UNITED STATES PATENT AND TRADEMARK OFFICE

Office Action Summary	Application No. 10/605,892	Applicant(s) LI, CHAO-KANG	
	Examiner Noah C. Hawk	Art Unit 3637

DETAILED ACTION

Le et al. Figure 10

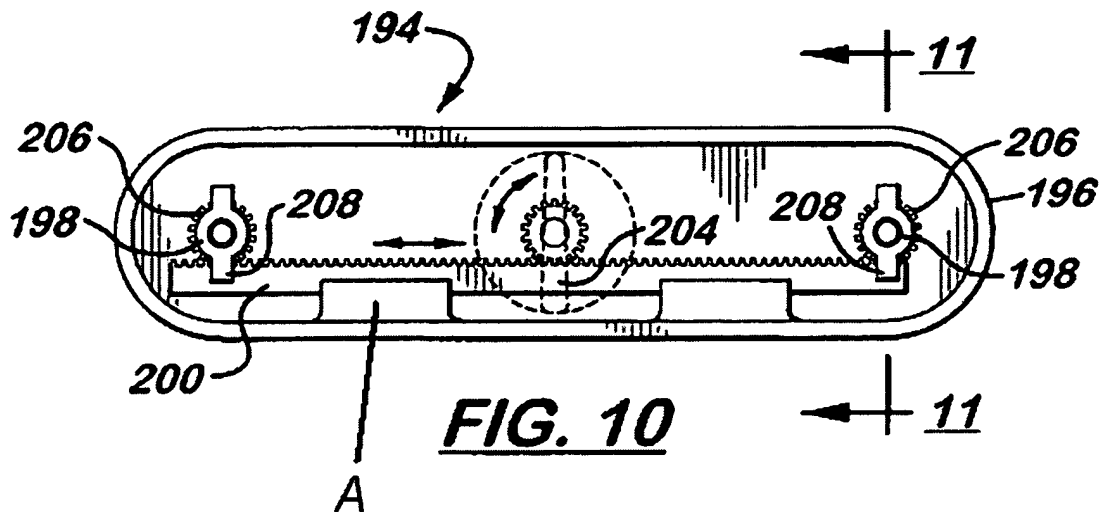
9. Regarding Claims 4 and 12, Le et al. further teach a sliding portion having a first track (200) and a fastening base (194) having a second track (A) corresponding to the first track so that the sliding portion moves with respect to the fastening base along the first and second tracks between the first and second positions.

10. Regarding Claims 7 and 15, Le et al. further teach a fastening base (194) with a first stop block and second stop block (180) on the fastening base for preventing the sliding portion from detaching from the fastening base during linear movement (see Le et al., column 7, lines 29-32).

11. Regarding Claims 17 and 18, Le et al. further teach that the fastening base (194) has an opening (the opening comprising the concave space defined by exterior wall 196 on the side of the fastening base with first track 200).

Chen et al. Figure 1

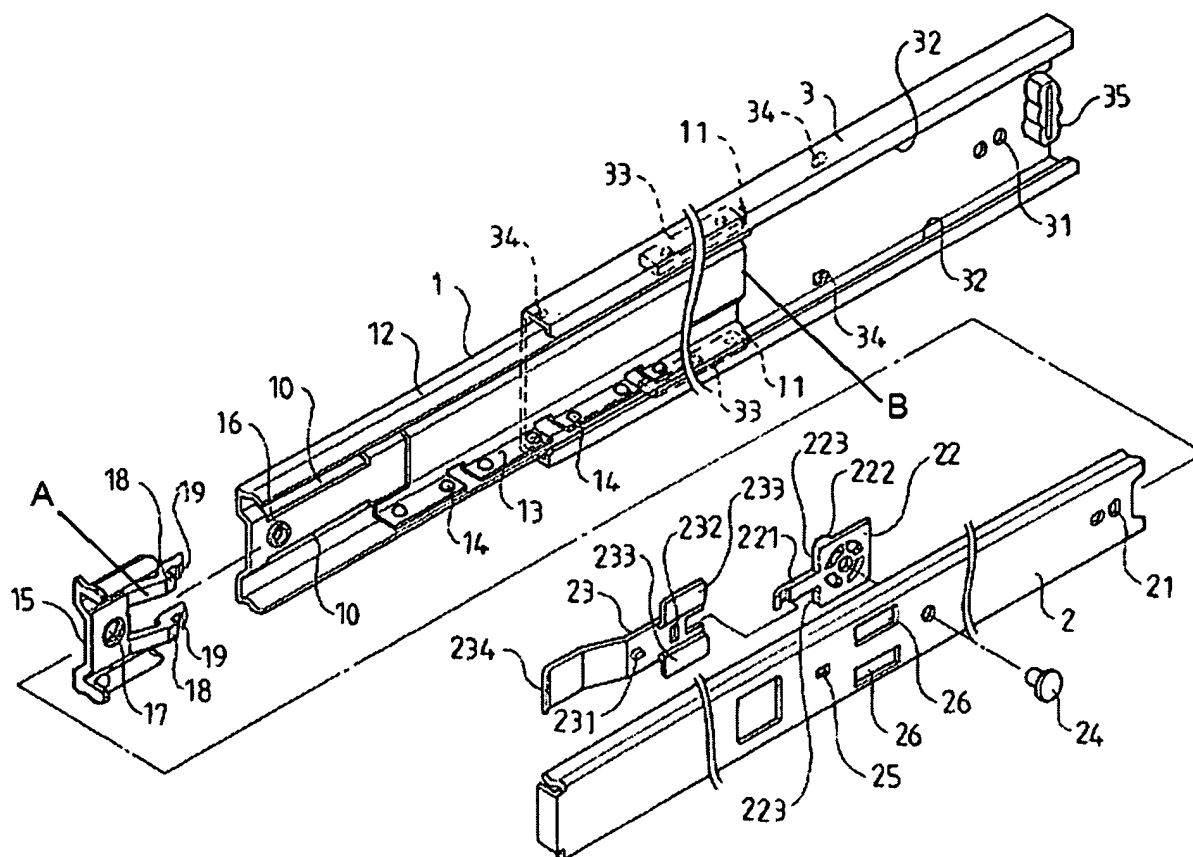
a. Regarding Claims 6 and 14, Le et al. do not disclose a first assembly error prevention assembly or a second assembly error prevention structure. Chen et al. disclose a sliding device with a sliding portion (1) having a first assembly error prevention device (B) attached to a fastening base (3) with a second assembly error prevention device (35). It would have been obvious to one of ordinary skill in the art at the time of invention to modify Le et al's storage device fastening apparatus by using first and second assembly error prevention devices as taught by Chen et al. in order to prevent assembly error.

b. Regarding Claims 8 and 16, Le et al. do not disclose a first stop block with an inclined surface. Chen et al. disclose a sliding device with a stop block (15) having an inclined surface (A). It would have been obvious to one of ordinary skill in the art at the time of invention to modify Le et al's storage device fastening apparatus by using a stop block with an inclined surface as taught by Chen et al. in order to assist in the assembly of the sliding portion with the fastening base.
